Hume Amendment C208

Expert Evidence Statement

Prepared for
Wincity

14 August 2017

Figure 6-2 Lancefield Road PSP – Emu Creek Local Town Centre Concept

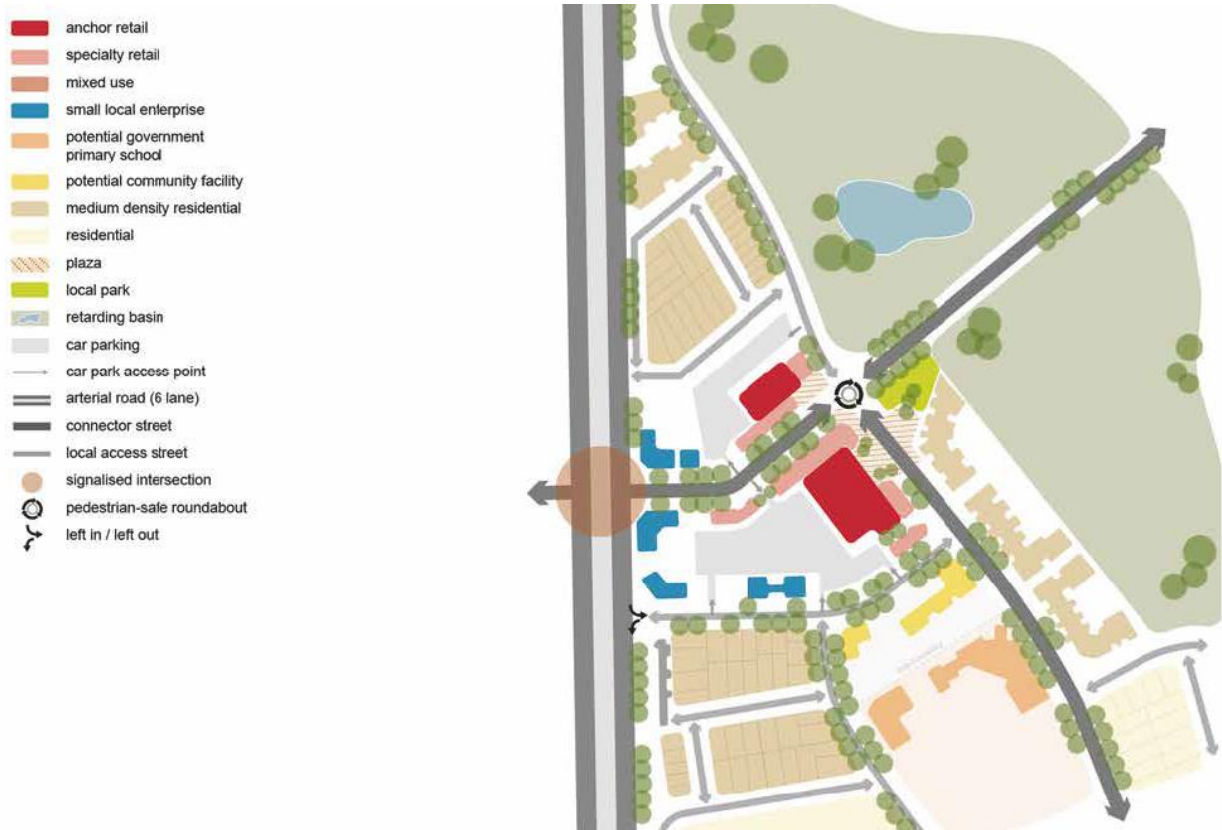
I am of the opinion that the Main Street should intersect with Lancefield Road at right angles and remain straight for at least 30m from the intersection. Appropriate curve radii should be applied as per the intersection design provided to allow for safe passage through the intersection. This will allow transition to the angled alignment as required. This concept is shown within the existing PSP document and should be retained. I do not believe that a “kinked” approach provides an appropriately safe intersection design for a greenfield site.

Figure 6-3 Lancefield Road Cross Section

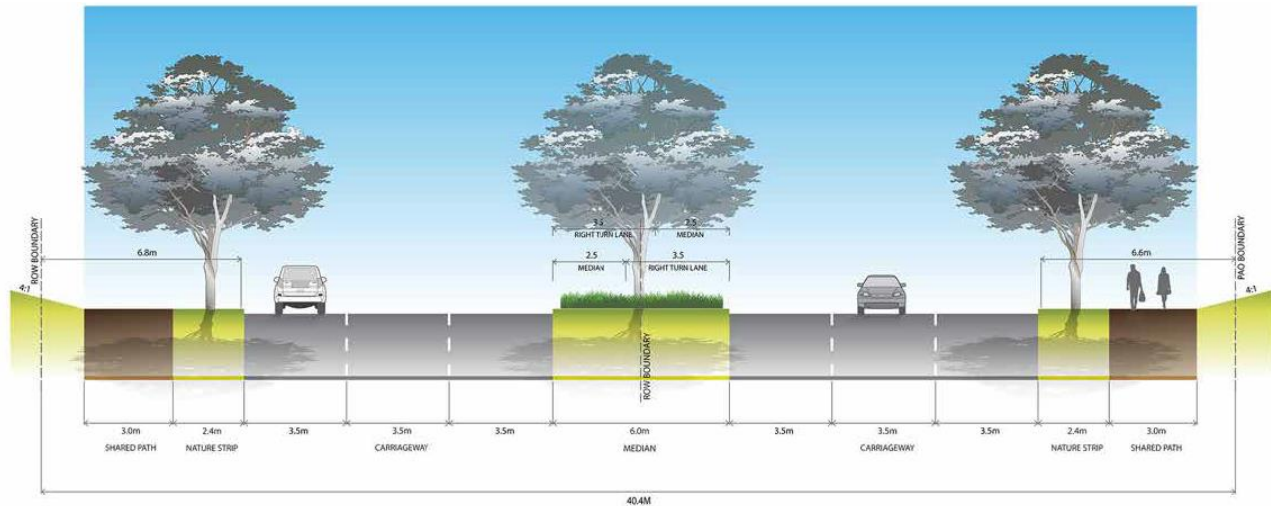
The road reserve as defined by the PSP has been overlaid onto the intersection plan. I am of the opinion that additional localised widening of the road reserve / PAO would be required where left turn lanes develop in the vicinity of Lancefield Road / Main Street intersection and the left-in/left-out access point to the Access Street immediately south of the main intersection. This additional localised widening is only required if and when Lancefield Road contains six lanes, which is unlikely to occur in the foreseeable future. The future urban growth boundary does not extend much further north along Lancefield Road and in my opinion the warrants for a six lane cross section are questionable.

Figure 6-5 Main Street Road Cross Section

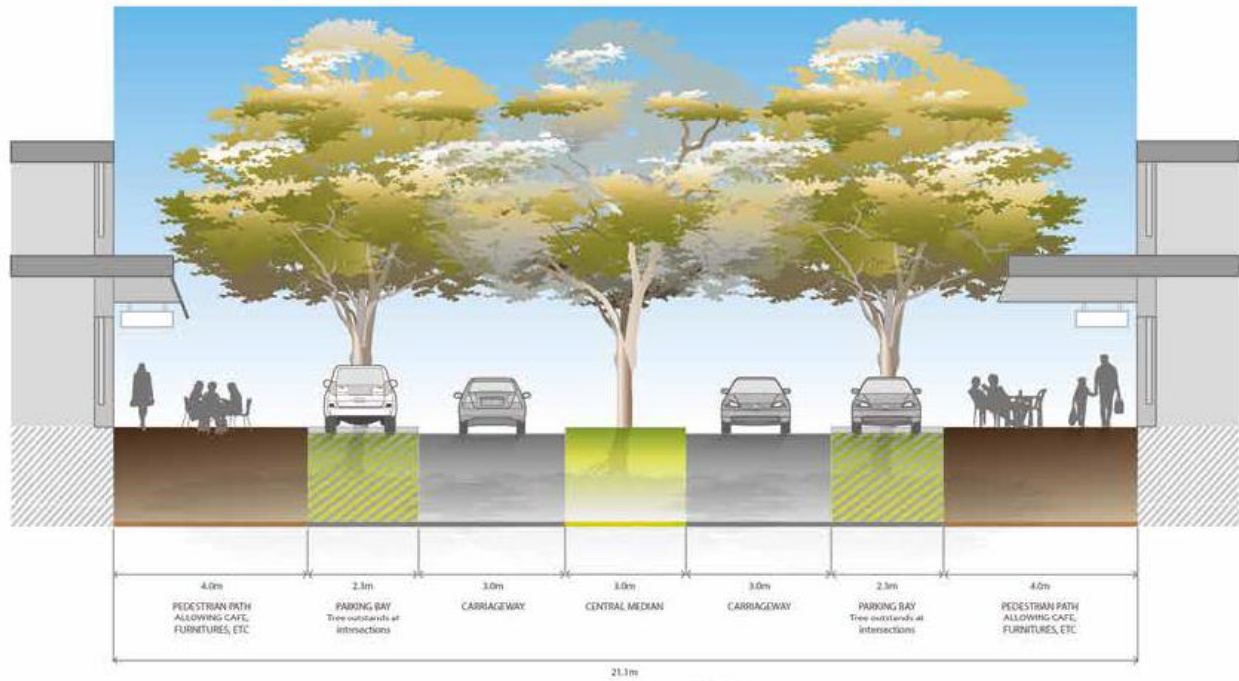
The main street cross section as defined within the PSP allows for 3.0m through lanes. This does not allow for the standard lane width for bus movements (3.5m lanes required). I am of the opinion that it would be appropriate to amend the PSP cross-section to allow for wider carriageway widths to facilitate future bus movements within the Main Street, which would require at least 22.6m. This is slightly narrower than a connector street cross section of 25m.

Figure 7-1 Taylors 96A submission Layout

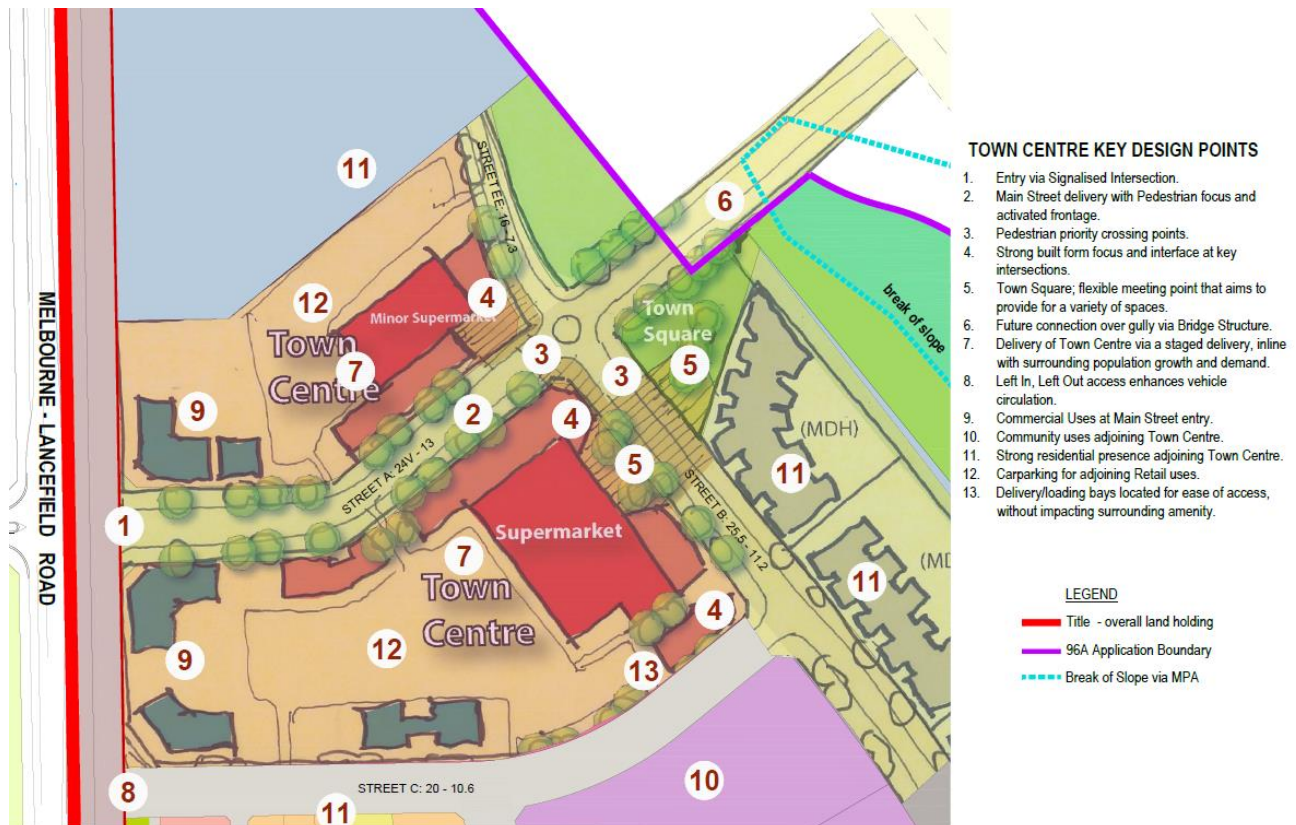
Excerpts of both plans are shown below in Figure 7-1 Figure 7-2. The Taylors Plan is generally in accordance with the PSP document (shown in Section 6.1.2), whereas the DLA layout differs with in the following ways:

- The connector/main street is angled at approximately 70 degrees from the intersection rather than 90 degrees;
- Additional access roads are shown within the town centre area;
- The intersection to the north-east between the two connector roads is not a cross intersection controlled by a roundabout, but a t-intersection;
- The left-in/left-out treatment is located closer to the signalised intersection.

ULTIMATE
INTERSECTION
CONCEPT DESIGN

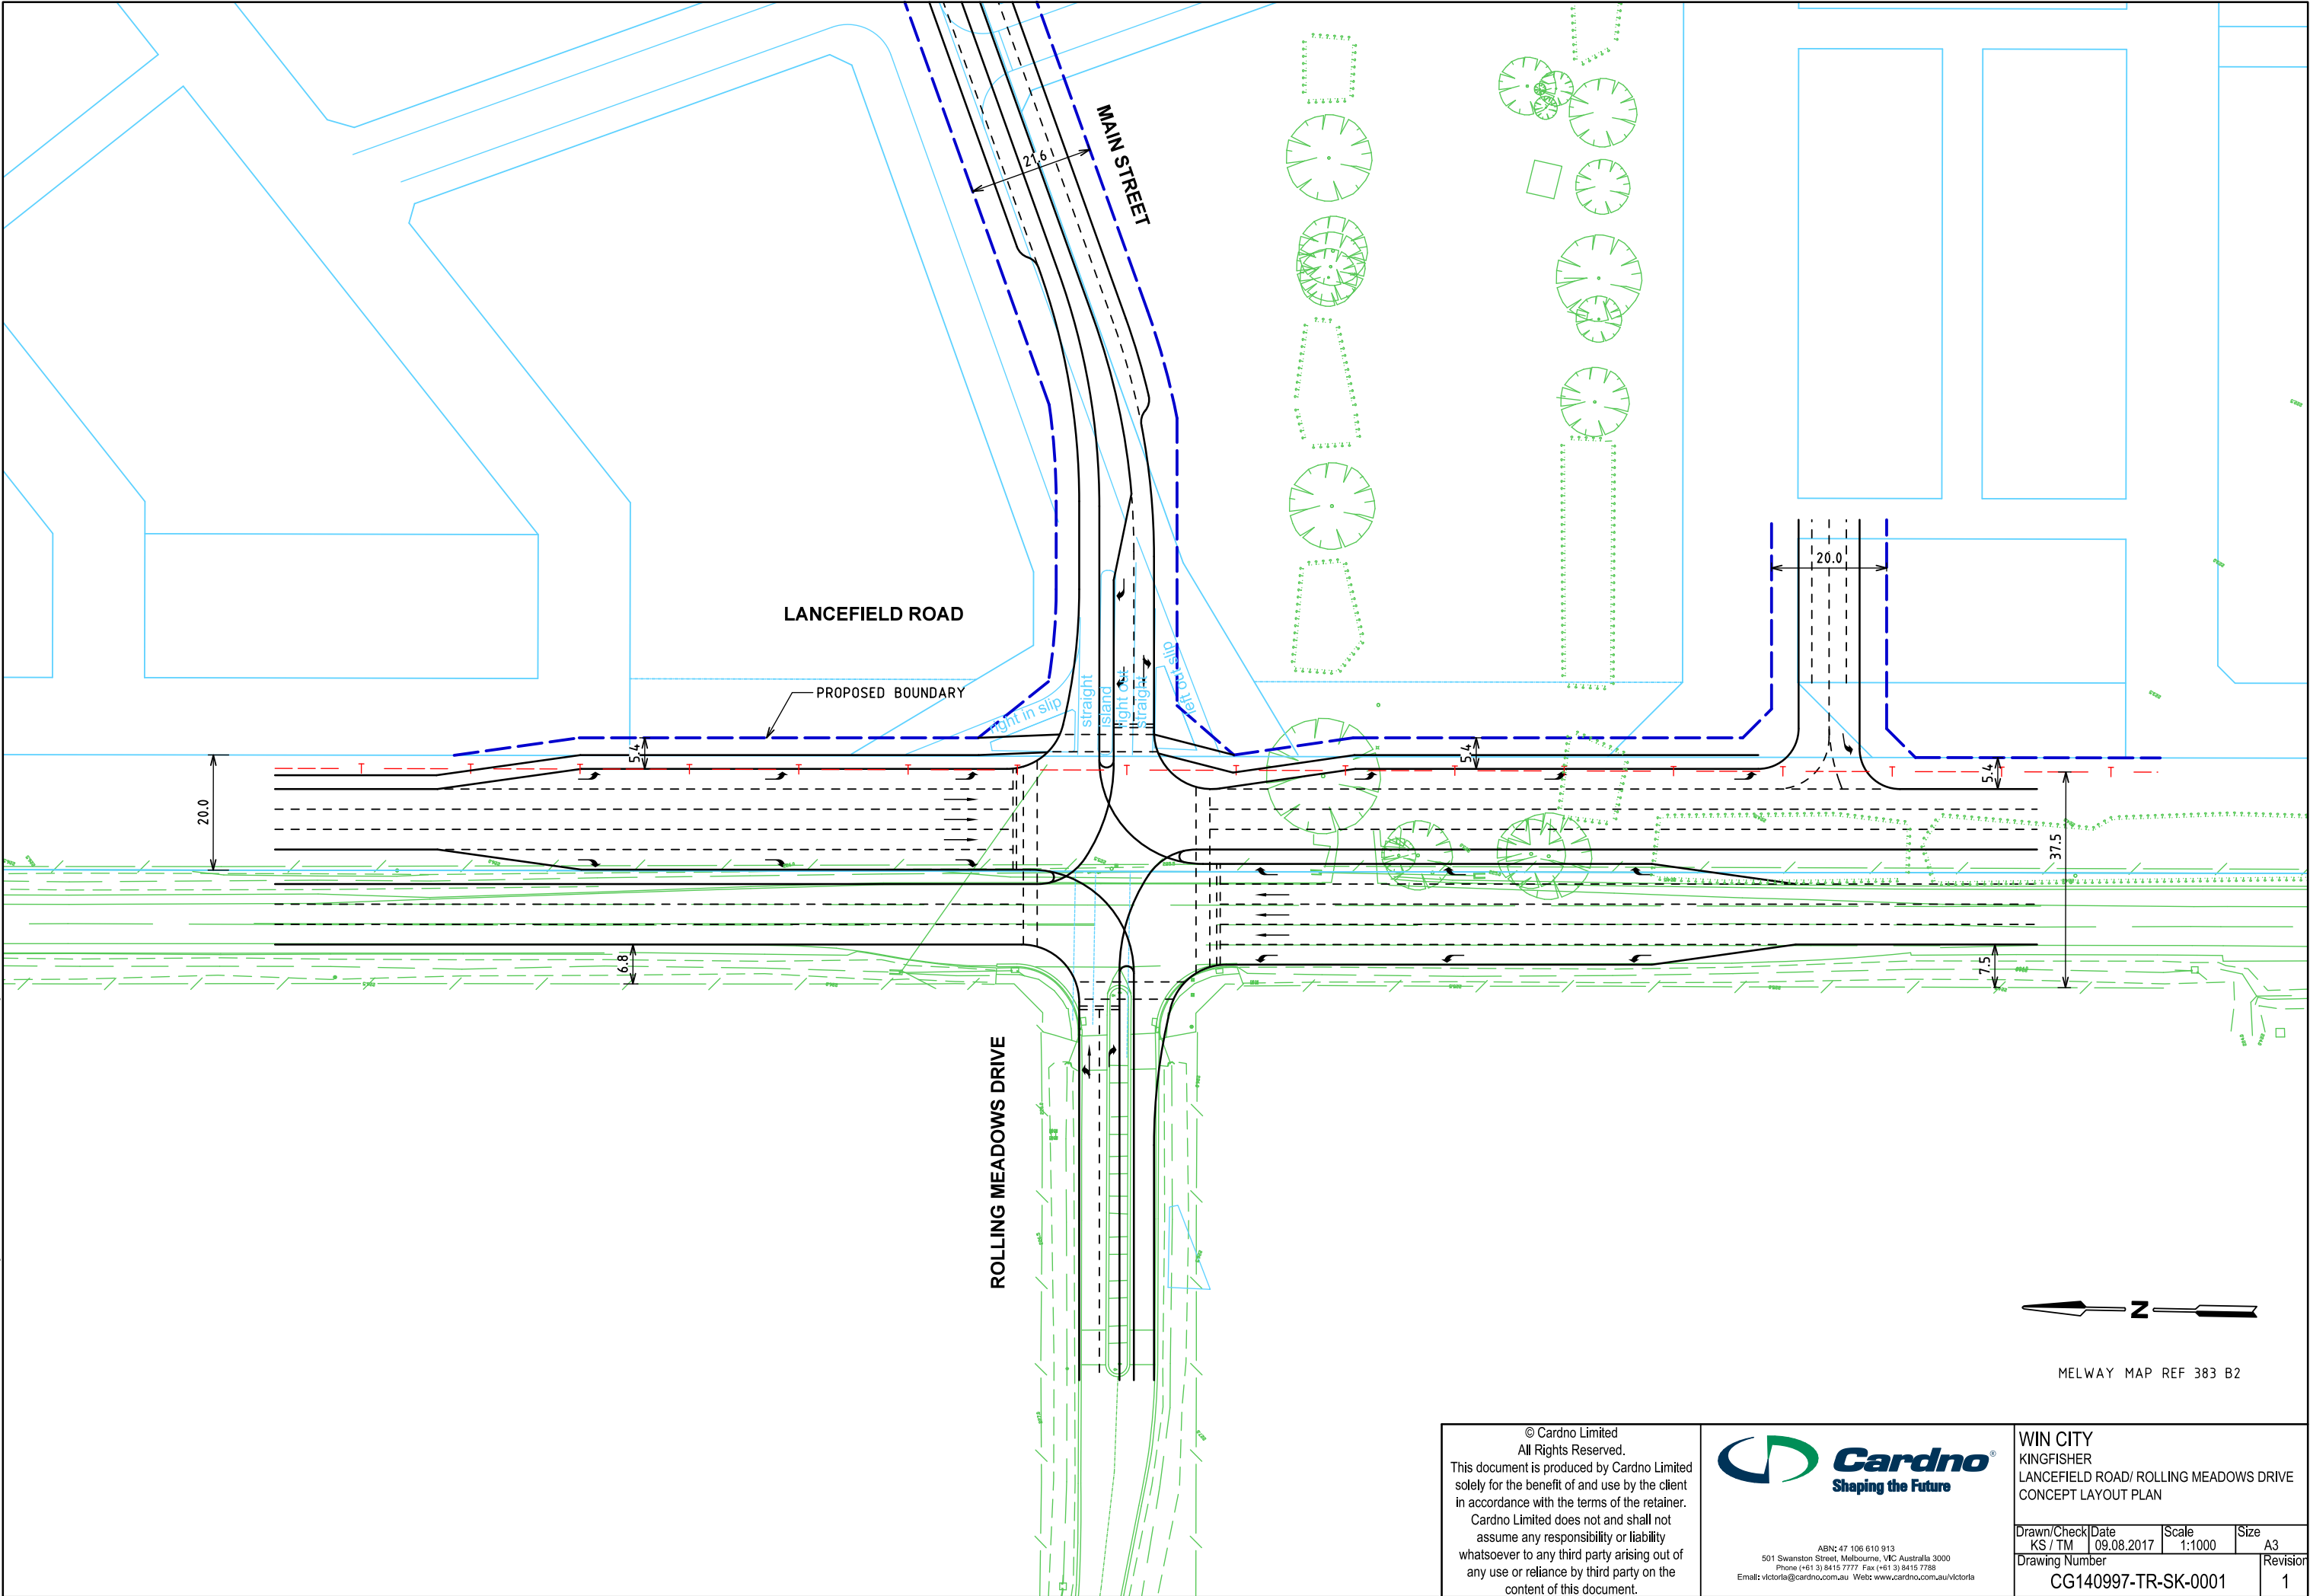
Based on the cross section provided within the PSP for Lancefield Road, as well as the PSP Guideline 60 with respect to signalised intersections (to be designed in accordance with VicRoads Growth Area Road Network Planning Guidance and Policy Principles), I have designed the intersection of Lancefield Road as a Primary Arterial / Connector Road intersection. This intersection design is attached as Appendix A. The design takes into account the following features:

- PSP cross sections for the through lanes along Main Street and Lancefield Road;
- Deceleration and storage lengths for turning lanes along Lancefield Road for the design speed of 80km/h, with appropriate splays provided at the intersection;
- Standard turning lanes for Collector/Main Streets as they intersect with Lancefield Road;
- Appropriate sight distance to signals along Main Street for an approach speed of 50km/h;
- The Lancefield Road intersection aligning at 90 degrees to Rolling Meadows Drive and Main Street as per Austroads Guide to Road Design – Part 4A.

I am of the opinion that the standard intersection design as referenced within the PSP guidelines can be accommodated at this location with some minor adjustments to property boundaries. The Precinct Infrastructure Plan describes the intersection works as “Land for the ultimate configuration and construction of an Interim 4 way signalised intersection”. The interim intersection is likely to be configured similarly to the concept design provided in the 96A application traffic report prepared by Cardno in 2015 as shown in Appendix B.

I am of the opinion that the left-in/left-out intersection to the south of the intersection can be accommodated and will provide additional access to/from the town centre car park. The location of this access point must however be appropriately located to allow for the development of a deceleration lane for left turners along Lancefield Road as shown in the intersection concept layout.
